UNITED STATES PATENT AND TRADEMARK OFFICE

APPLICATION NO.	FILING DATE	FIRST NAMED INVENTOR	ATTORNEY DOCKET NO.	CONFIRMATION NO.
10/028,419	12/21/2001	Joseph Vanniasinkam	M-9340 US	3557
22852	7590	06/14/2005	EXAMINER	
FINNEGAN, HENDERSON, FARABOW, GARRETT & DUNNER LLP 901 NEW YORK AVENUE, NW WASHINGTON, DC 20001-4413			KIANNI, KAVEH C	
			ART UNIT	PAPER NUMBER
			2883

Office Action Summary

DETAILED ACTION

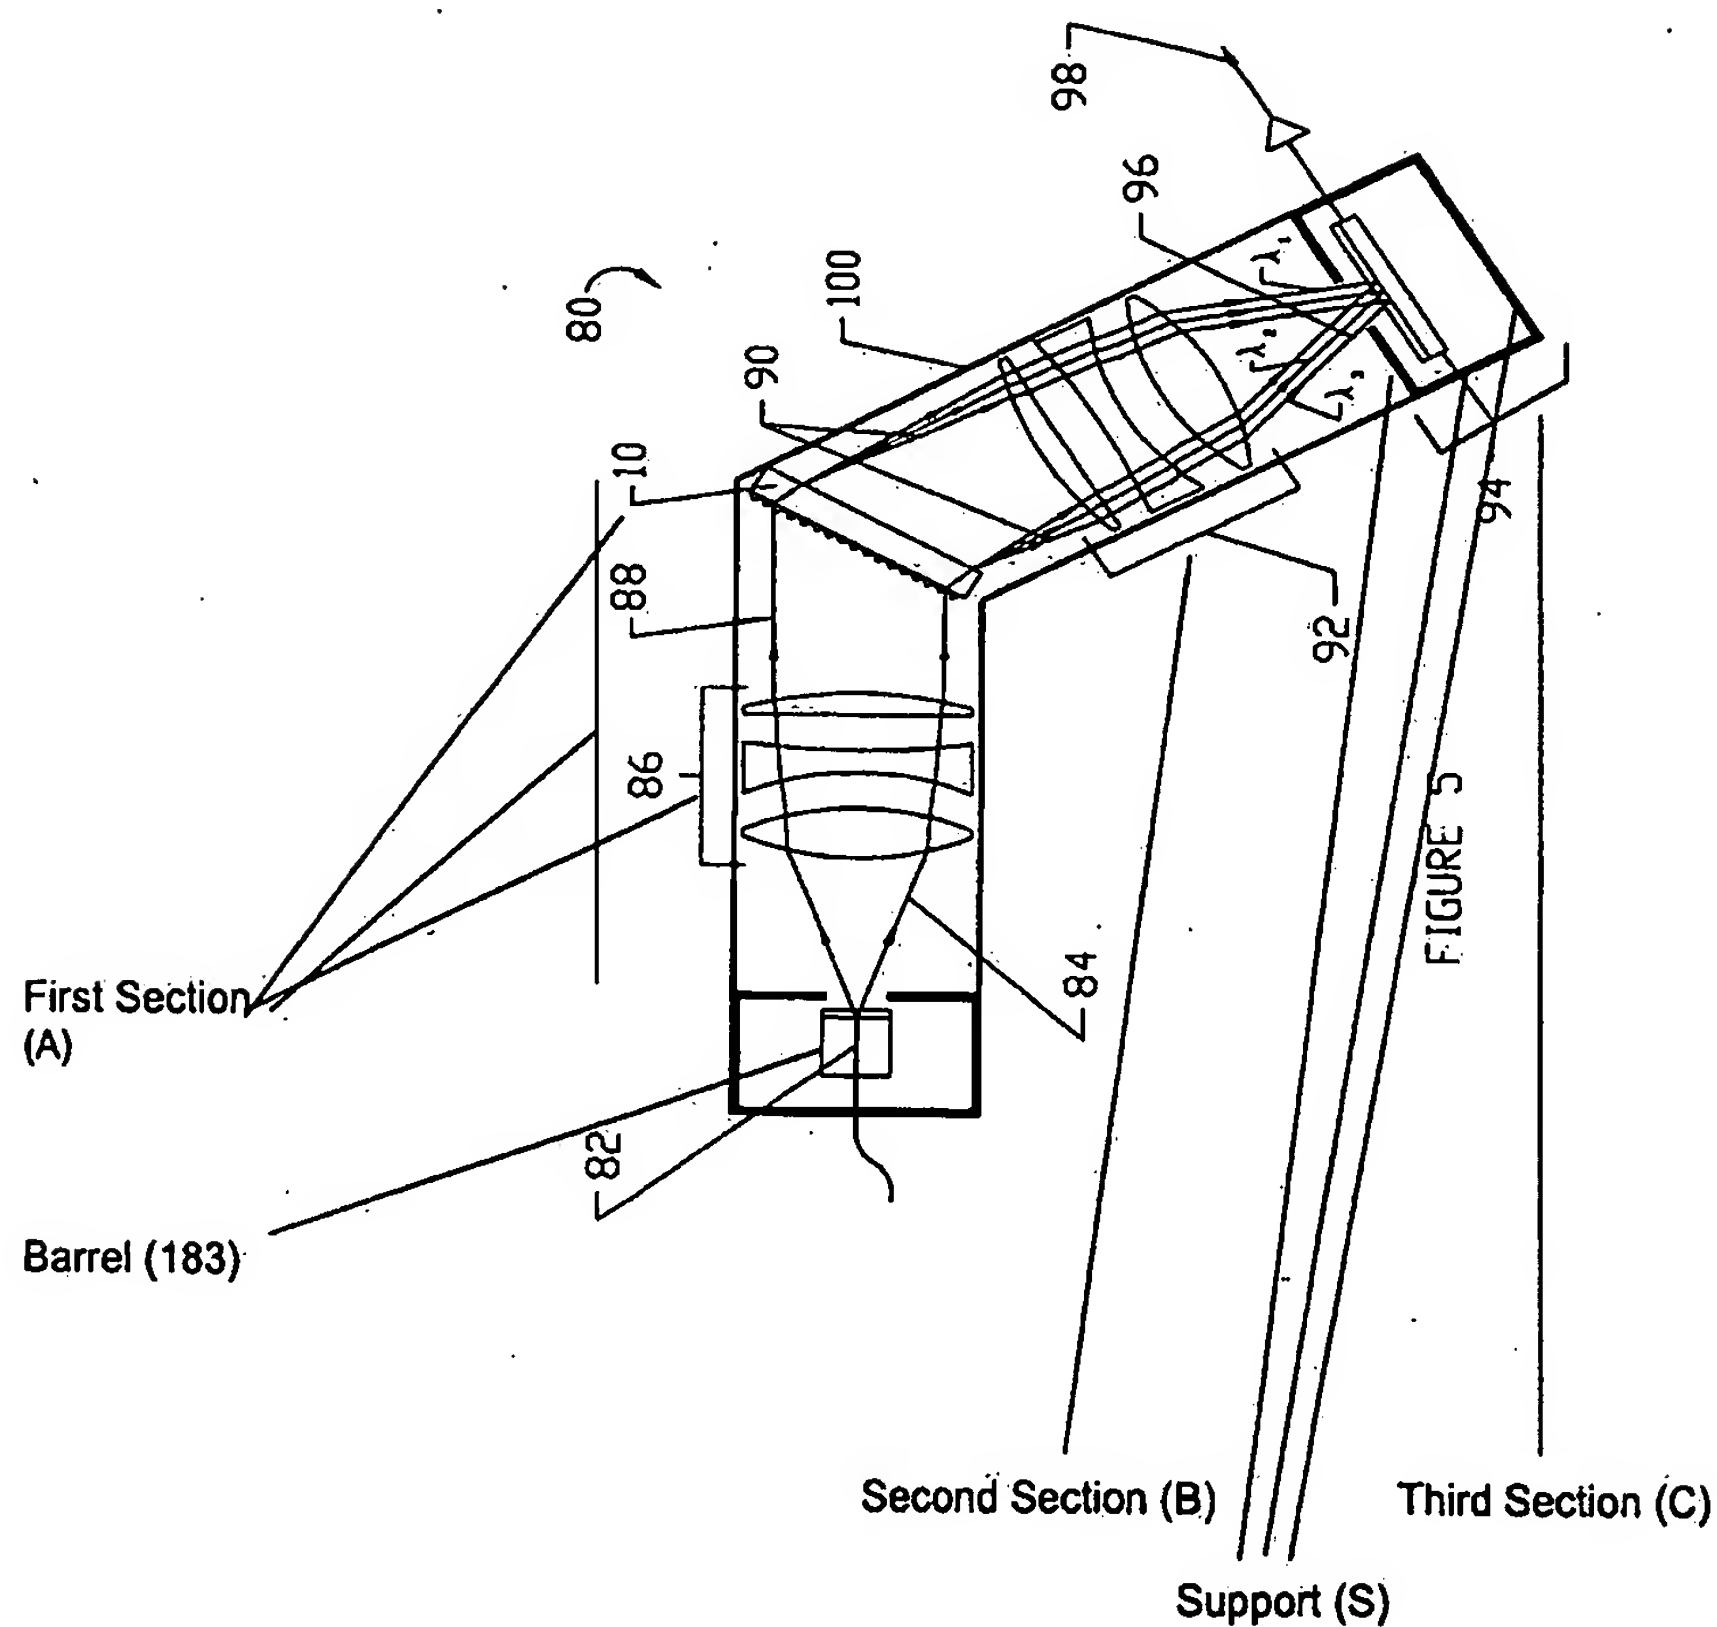
Claims 1-15 and 23 are rejected under 35 U.S.C. 103(a) as being unpatentable over Kramer (US 6583934).

Regarding claims 1-6 and 12-13, Kramer teaches a monitoring device (shown in at least figure 5, see above figure), comprising:

a first section A capable of receiving a WDM beam (see fig 5, item first section A containing lens assembly 86 and grating 10 for receives WDM beam via fiber 82; see also col. 13, lines 48-52),

a diffraction grating 10 integrally formed with the first section A (shown in fig. 5, item diffraction grating 10 integrally formed in the first section via housing 100), the WDM beam 88 being directed onto the internal surface of the diffraction grating 10 (shown in fig. 5, item 10 receives WDM beam), the diffraction grating/means 10 providing angularly separated beams $\lambda 1.. \lambda 3$ on the external surface of the diffraction grating 10; a second section B (see second section for collimating and focusing diffracted beam 90) integrally formed with the first section A; and

a third section C integrally formed with the second section B, the third section C positioned relative to the first section C to receive spatially separated light beams 90 of a selected diffraction order $\lambda 1.. \lambda 3$ from the diffraction grating 10 (shown in fig. 5, item third section C receives spatially separated light beams of a selected diffraction order $\lambda 1.. \lambda 3$ from the diffraction grating 10);

wherein the first section A, the second section B, the third section C, and the diffraction grating 10 are integrally formed in a single piece (see fig. 5, wherein the first section A, the second section B, and the third section C are integrally formed in a single piece through housing 100) using a molding process (this limitation has not given a patentable weight by the examiner because as stated in the MPEM 2144.04, such as in section V.B does not warrant patentability based on integrally forming a device, such as by molding process; further the presence of process limitations on product claims, which product does not otherwise patentably distinguish over prior art, cannot impart patentability to the product *In re Stephens*, 145 USPQ 656 (CCPA 1965). See also 2113 Product-by-Process Claims: "[E]ven though product-by-process claims are limited by and defined by the process, determination of patentability is based on the product itself. The

Regarding claims 23, Kramer teaches a monitoring device (shown in at least figure 5, see above), comprising:

means for separating an input light beam 88 into constituent parts $\lambda 1.. \lambda 3$ with a integrally formed component 10 (see fig. 5, above, first section S through grating 10 separates input beam 88 into $\lambda 1.. \lambda 3$);

means 100 for aligning the means for separating (see first section S) with the means for detecting 94 (see the housing 100, inherently, aligns the first section S--for separating the input light beam 88 into constituent parts $\lambda 1.. \lambda 3$ —with that of the detector 94; note that this alignment scheme is analogous to the applicant's aligning means—i.e., as stated in the specification parag. 0034 with regard to alignment of the elements/means in figure 2). Regarding Kramer's teachings of demultiplexer the arguments presented in rejection of claim 1 is analogous in rejection of claim 23.

Regarding applicant's assertion that Kramer does not teach wherein the first section, the second section, the third section, and the diffraction grating are integrally formed in a single piece using a molding process the examiner responds that as shown in figure 5 (*and as illustrated by the examiner in the previous office action*), Kramer teaches a third section C integrally formed with the second section C and the first section A; the first, second and the third sections A-C are integrally formed in a single piece as shown in figure 5, and further, Kramer teaches a means (section C) for separating an input light beam 88 into constituent parts $\lambda 1.. \lambda 3$ with an integrally formed single piece component 10. Thus, various components in the first, second and third sections A-C elements such as lens 86 and barrel 183 are integrally formed into a single piece as shown in figure 5. Further, as stated in the telephone interview with Mr. Edwards on June 05, 05 even with insertion of a suggested limitation 'wherein the multiplexer substantially aligned upon formation' does not place the application in the condition of allowance since with the presence of new references in a new search by the examiner showed that the molding process in WDM is well known in the art in which at least one of the references discussed by the examiner teaches all limitations of the base claim including alignment by molding process. Also the MPEM section 2144.04,
